General Bulletin 2017001

Hydraulic Swivel Coupling

Subject:	Replacing Hydraulic Swivel Couplings
Attn:	IMT Distributors
From:	IMT Technical Support (800-554-4421 or 641-923-4633)
Date:	March, 2017
Affected Models:	Cranes: 9/65 through 26/180

MAST DRAWING

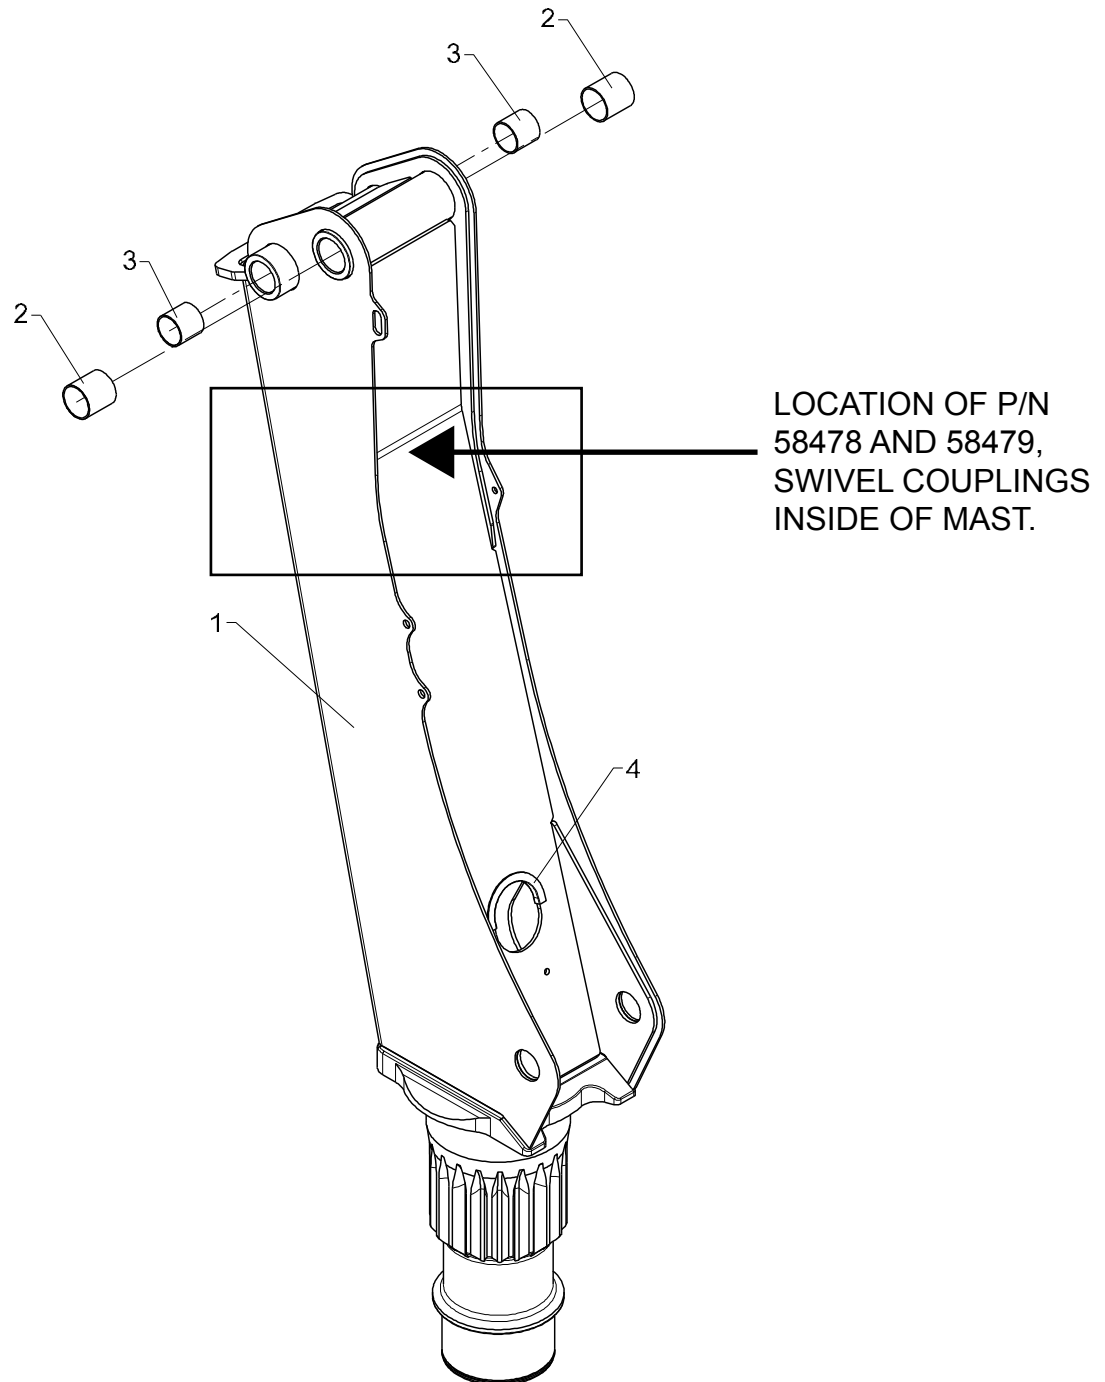
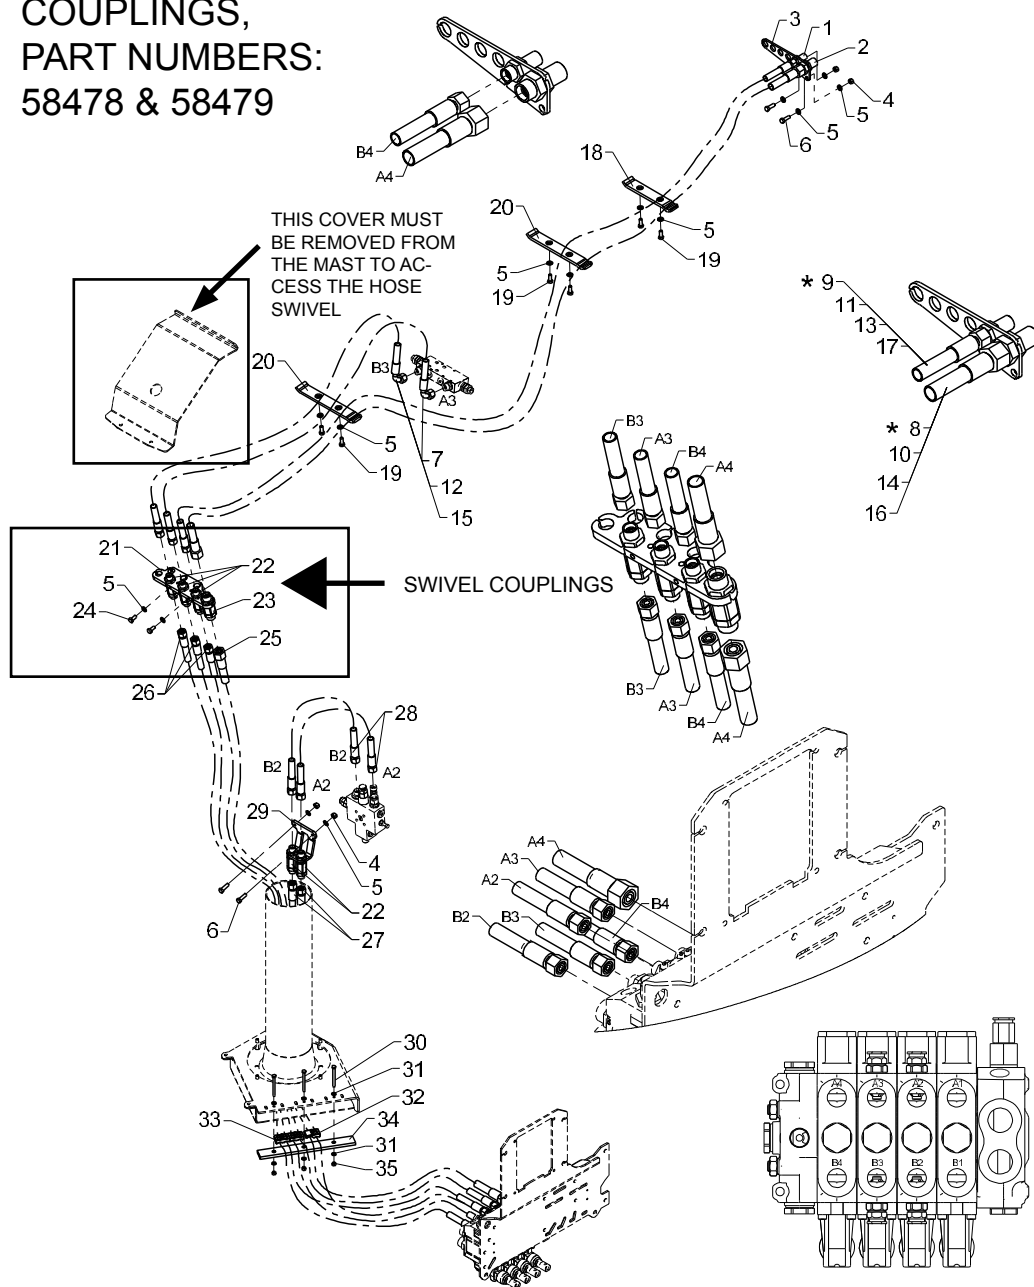
Our goal at IMT is to continuously look for ways to improve our manufacturing processes so we can ensure our customers are receiving the highest quality product and service. This general bulletin is to notify our distributors that a leak is possible from the hydraulic swivel couplings on models 9/65 through 26/180, especially with high temperatures in the hydraulic system. The leak will develop as and remain a slow leak. The defect was detected through warranty claims filed by customers. This bulletin contains instructions and an order form for warranty parts and labor hours located on the last page.

SWIVEL
COUPLINGS,
PART NUMBERS:
58478 & 58479

Fig. 1

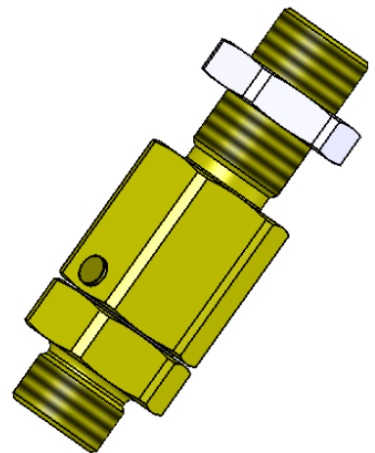
General bulletin 2016006, affects 9/65 through 26/180 model cranes, is to notify our distributors that a hydraulic leak, especially with high temperatures in the hydraulic system, can occur to a built-in seal inside the swivel coupling (not visible) due to a variation in the manufacturing process on two purchased part numbers:

58479 - Swivel, M24 x 1.5, which is installed in the hydraulic circuit for the “extension out” function and the winch.

58478 - Swivel Coupling, M18 x 1.5 is installed in all other hydraulic circuits.

Fig. 2

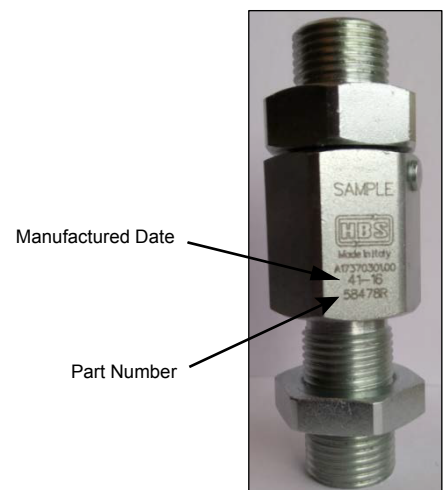
There will be an engraved manufacturing date stamped on a specific location on the outside of the swivel coupling. The picture example in Fig. 2, shows SAMPLE, and below this is the stamped number, 41-16. This number represents the week number of the year that it was manufactured. Any number that is stamped with 38-15 to 39-16, followed by the affected part number of 58478 or 58479, might need replacing.
